Project	IEEE 802.16 Broadband Wireless Access Working Group < http://ieee802.org/16 >	
Title	Changes to Figures 44 and 46 as a consequence of Comment 98.	
Date Submitted	2004-04-29	
Source(s)	David A Castelow, Gavin Meakes Airspan Communications, Cambridge House, Oxford Road, Uxbridge, UK	Voice: +44 1895 467281 Fax: +44 1895 467202 mailto:dcastelow@airspan.com
Re:	Supporting document for Sponsor Ballot Recirculation	
Abstract	Additional changes to the standard are required as a result of the Resolution of Comment 263	
Purpose	The document is intended for consideration within comments resolution process.	
Notice	This document has been prepared to assist IEEE 802.16. It is offered as a basis for discussion and is not binding on the contributing individual(s) or organization(s). The material in this document is subject to change in form and content after further study. The contributor(s) reserve(s) the right to add, amend or withdraw material contained herein.

Changes to Figures 44 and 46 as a consequence of Comment 98

David Castelow, Gavin Meakes

Figure 44—Maximum time relevance of DL-MAP and UL-MAP(TDD)

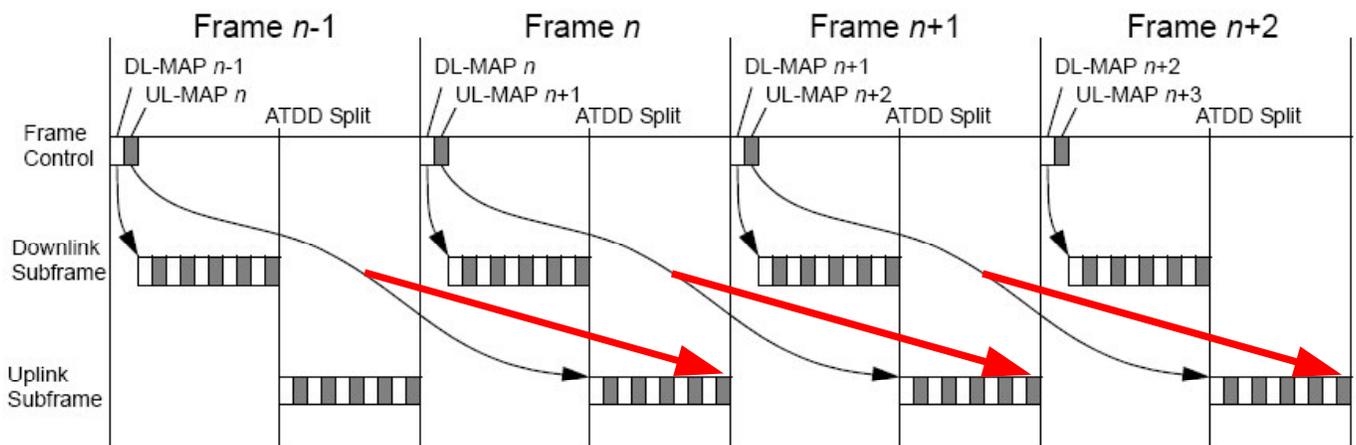
MAP validity diagrams do not appear to match my understanding of frames/subframes/.

Page 137, Figure 44 needs changing ...

Figure 46—Maximum time relevance of DL-MAP and UL-MAP (FDD)

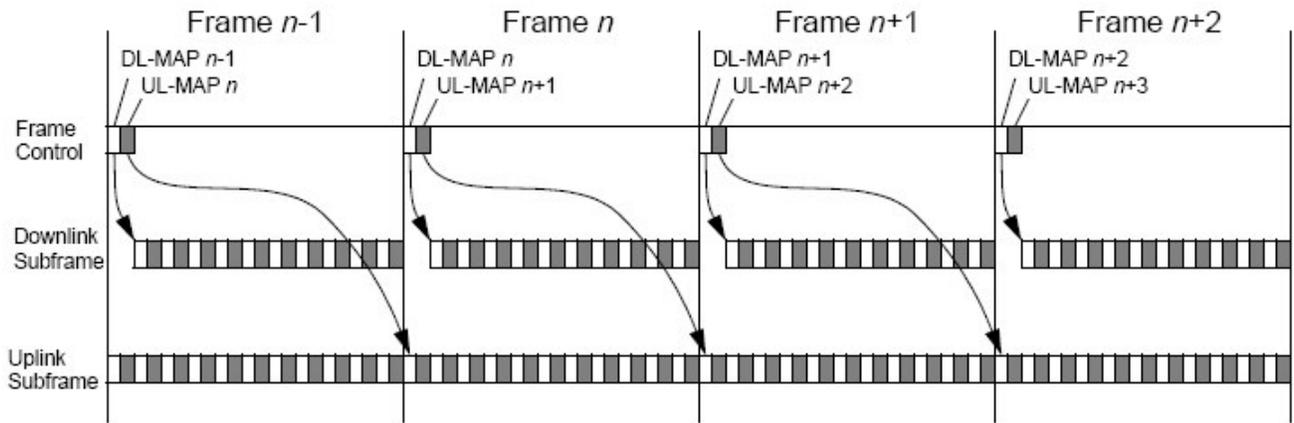
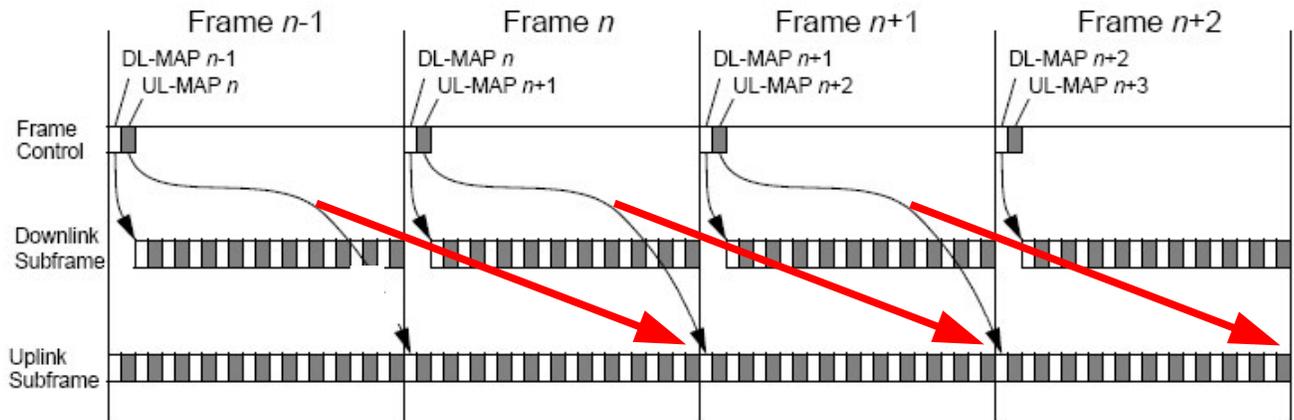
Page 138, Figure 46 needs changing by replacing UL arrows as indicated in second diagram in RED, from:
